Design Note 03

PROJECT:	Selkirk House, 166 High Holborn, 1 Museum Street, 10-12 Museum Street, 35-41 New Oxford Street and 16A-18 West Central Street		
TITLE:	MEINHARDT'S RESPONSE TO LLFA PLANNING COMMENTS		
REVISION:	01		
PREPARED BY:	Mr. C. Marchant	Date:	27 February 2023
REVIEWED BY:	Mr. C. Marchant	Date:	27 February 2023
APPROVED BY:	Mr. G. Bansal	Date:	27 February 2023

This design note has been prepared in response to the comments received from the London Borough of Camden (LBC), the Lead Local Flood Authority (LLFA) for the London Borough. The comments were received on 2nd February 2023, in relation to the proposed planning application submitted for the site; Selkirk House, 166 High Holborn, 1 Museum Street, 10-12 Museum Street, 35-41 New Oxford Street and 16A-18 West Central Street reference 2021/2954/P.

DRAWING No
2413-MHT-CV-DR-1MS-00101

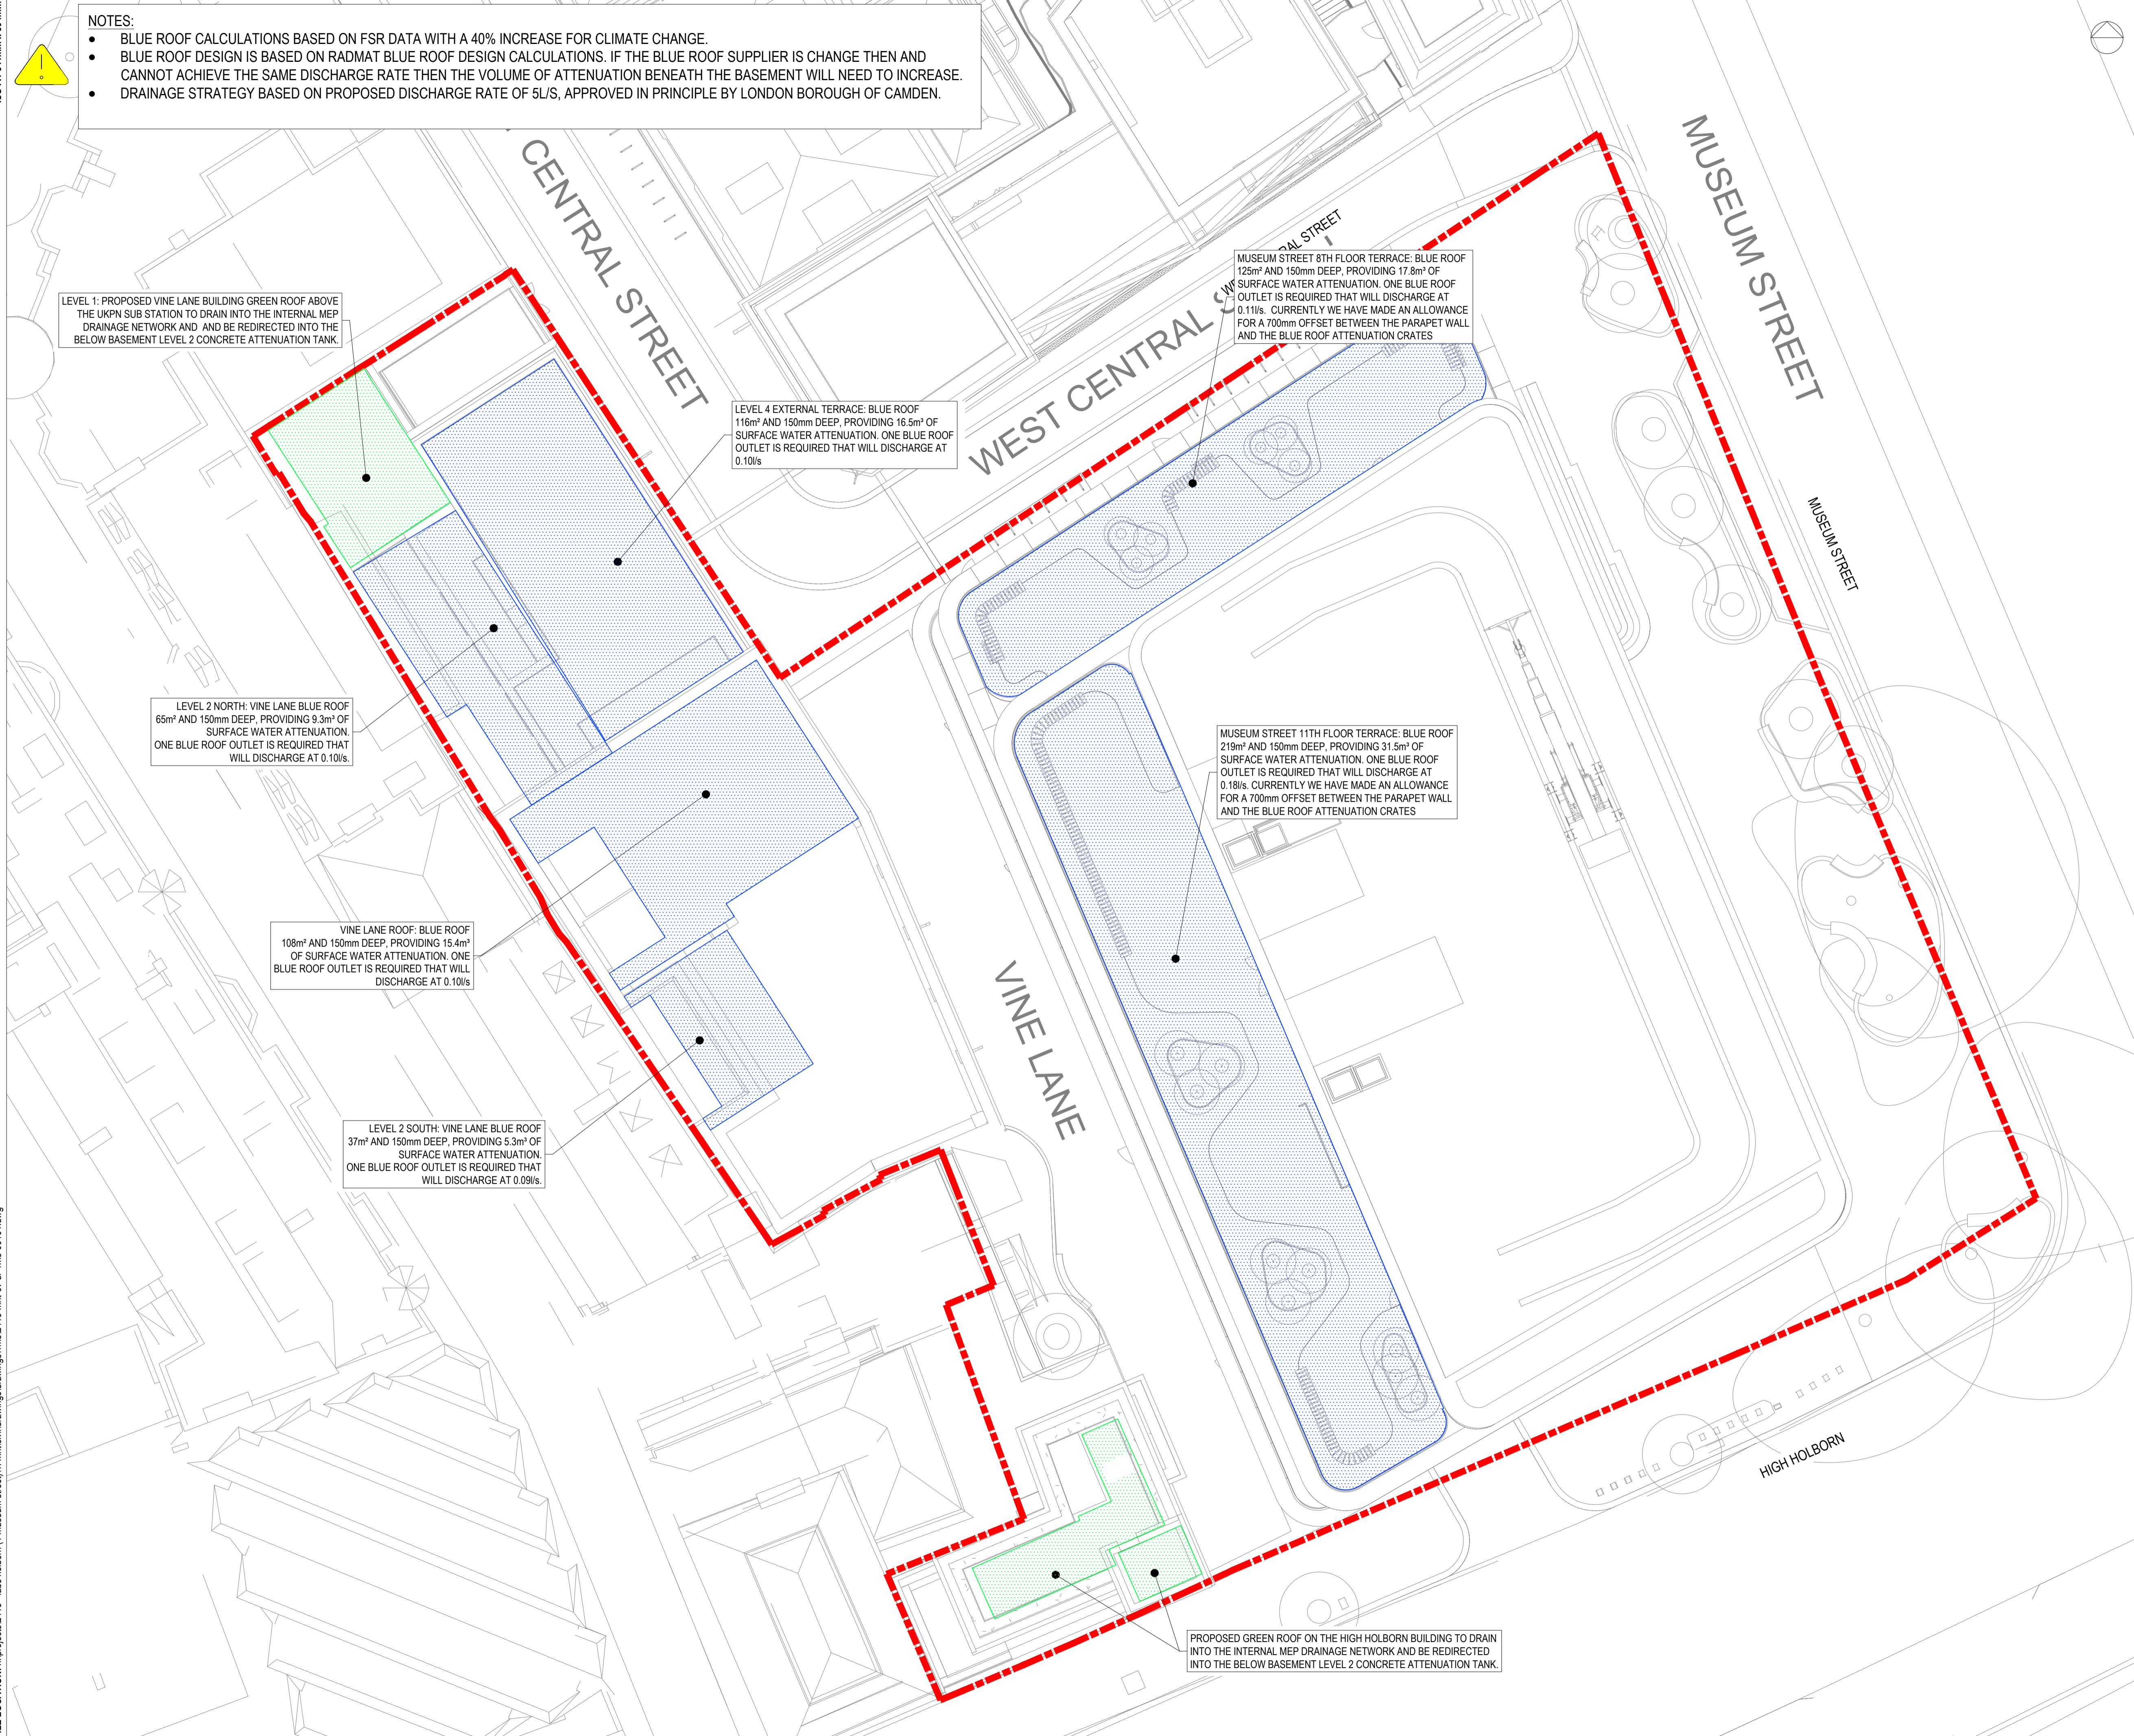
“Not all the blue roofs are a minimum 150mm thickness. The depth of the proposed green roofs are not clear”.

All of the proposed blue roof depths on the proposed Museum Street and the Vine Lane Building have been designed to be 150mm.

DISCIPLINE		SCALE @ A1	
CIVILS DRAWING		1:100	
DRAWN	DESIGNED	CHECKED	APPROVED
CM	CM	GB	PH
DRAWING No			ISSUE
2413-MHT-CV-DR-WCS-00099			P01

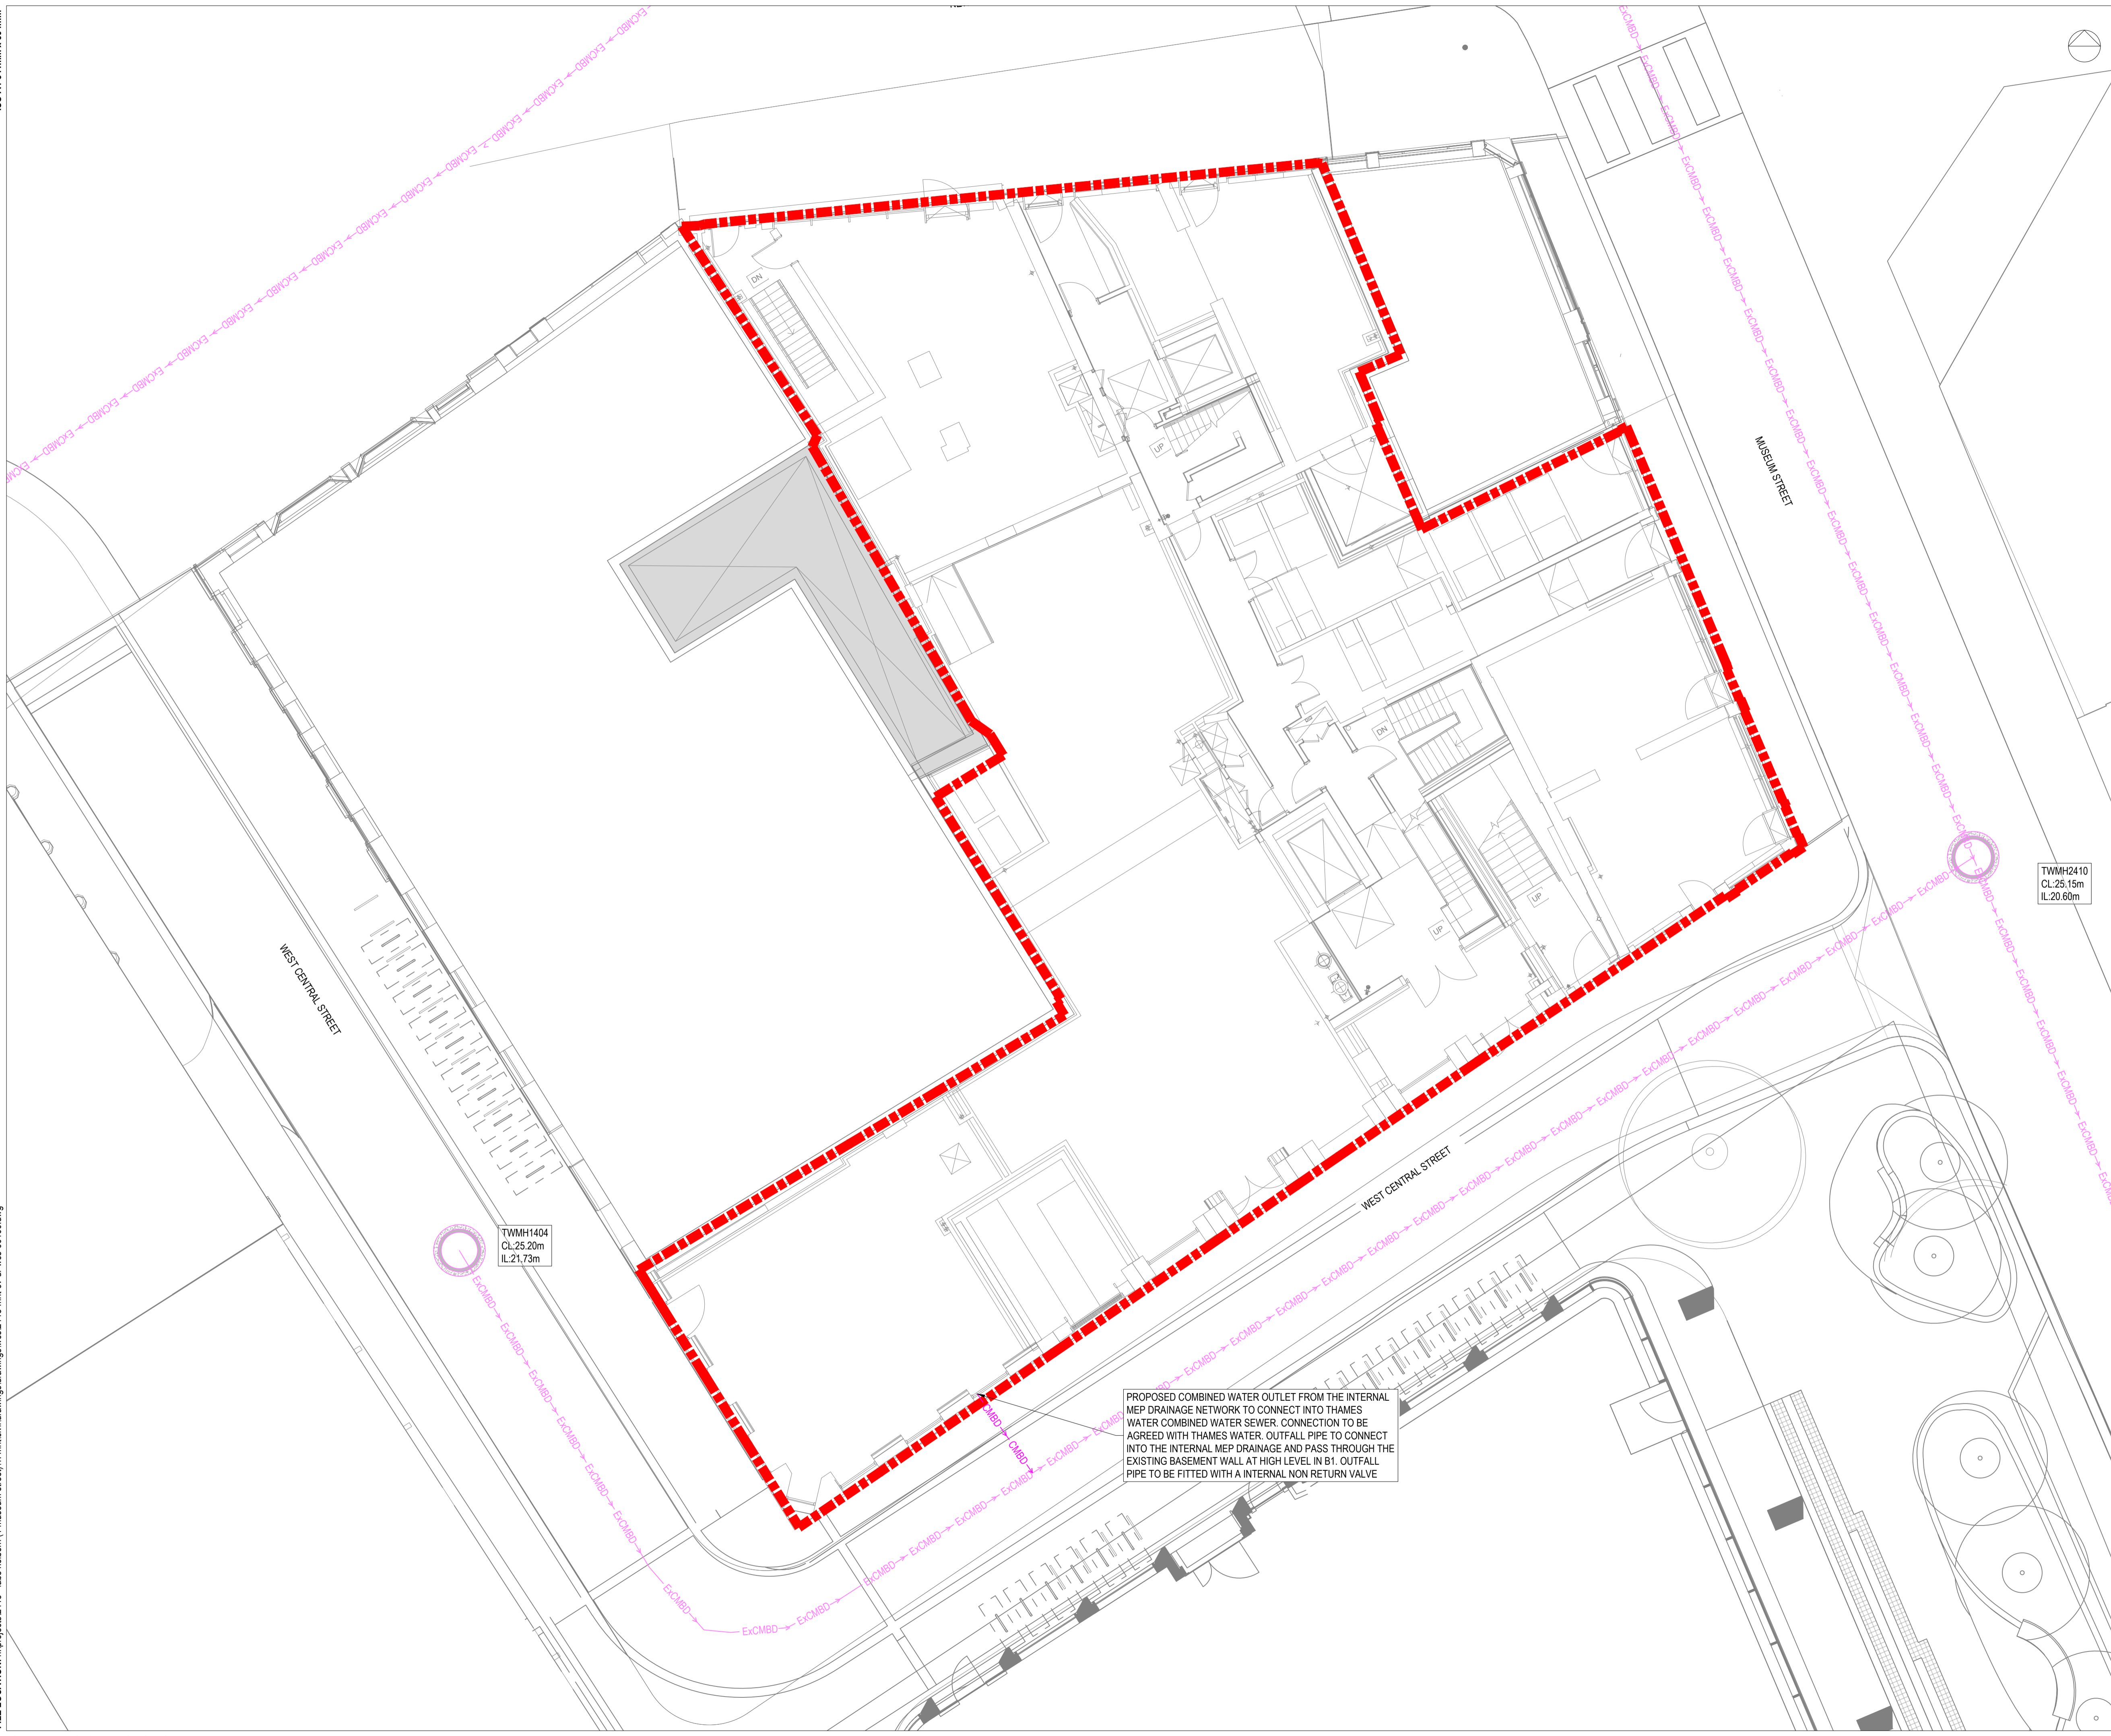
“It is not clear how many off-site discharge points are proposed and where these are located. The applicant has not confirmed the number and locations of off-site discharge points into the Thames Water combined sewer (this differs between drawings)”.

For the proposed West Central Street Building, we are proposing to create 3 x sewer connections to the Thames Water combined sewers. These connection points are shown on Drawings 2413-MHT-CV-DR-WCS-00099-P01 and 2413-MHT-CV-DR-WCS-00100-P01, these drawings can be found in Appendix B of the Drainage Strategy Report submitted for Planning.

The three drainage connection points from the West Central Street development have been summarised below:

- Reuse 1 x existing below basement foul water connection into existing Thames Water combined sewer with Museum Street.
- Reuse 1 x existing below basement foul water connection into the existing Thames Water combined sewer with New Oxford Street.
- 1 x new combined water connection from the Internal MEP below ground floor drainage into the Thames Water combined water sewer within West Central Street.
